Project	IEEE 802.16 Broadband Wireless Access Working Group < http://ieee802.org/16 >	
Title	STTD mapping for UL 2-antenna MIMO transmissions	
Date Submitted	2005-01-20	
Source:	Jianglei Ma, ,Peiying Zhu, Wen Tong, Ming Jia, Mo-Han Fong, Hang Zhang, Brian Johnson Nortel Networks 3500 Carling Avenue Ottawa, ON. K2H 8E9 CANADA	Voice: (613)-765-8089 Fax: (613)-765-7723 pyzhu@nortelnetworks.com
Re:	Call for Reply Comments regarding the Maintenance Task Group Comment Report 80216maint-04_09.zip	
Abstract	In this contribution, we propose to clarify the STTD mapping for UL 2-antenna MIMO transmission. Correction of typos in Blue font.	
Purpose	The contribution should be considered by Maintenance group within comment resolution procedure	
Notice	This document has been prepared to assist IEEE 802.16. It is offered as a basis for discussion and is not binding on the contributing individual(s) or organization(s). The material in this document is subject to change in form and content after further study. The contributor(s) reserve(s) the right to add, amend or withdraw material contained herein.

STTD mapping for UL 2-antenna MIMO transmissions

Figure 249a –UL STC tile

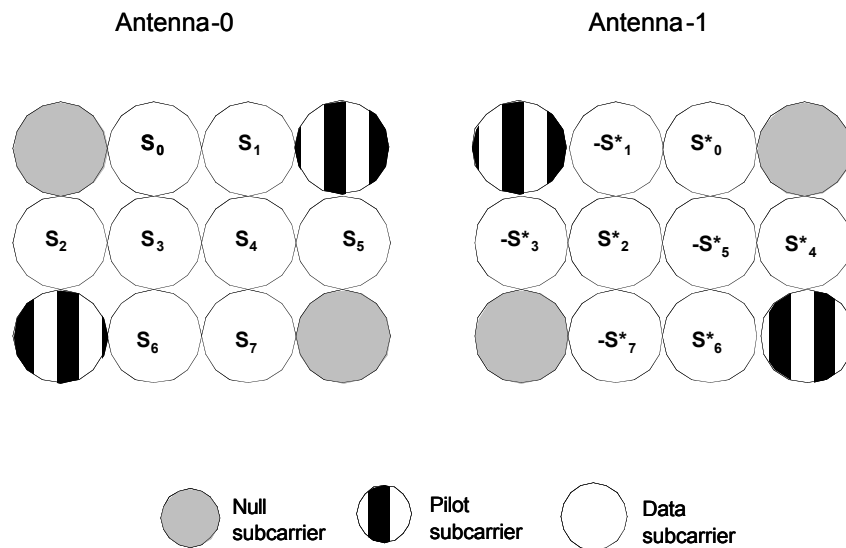
A user supporting transmission using STC configuration in the uplink, shall use a modified uplink tile, 2-transmit diversity data or 2-transmit spatial multiplexing data can be mapped onto each subcarrier, The mandatory tile shall be modified to accommodate those configurations. Figure 249a depicts the UL tile for STC transmission and mapping of matrix A.

Change Figure 249 in section 8.4.8.1.5

Figure 249b –UL STC Tile

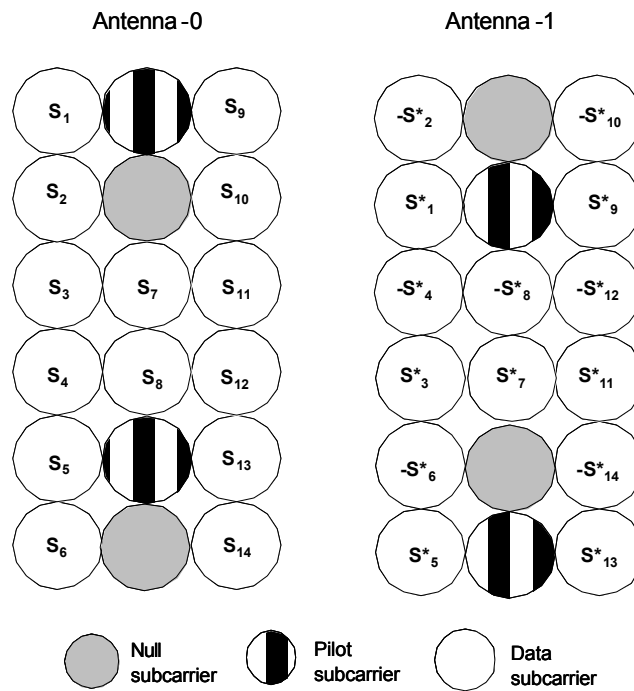
The optional uplink tile shall be modified to accommodate STC configurations. Figure 249b depicts the UL optional tile for STC transmission and mapping of matrix A.

Insert the Figure 249b in section 8.4.8.1.5
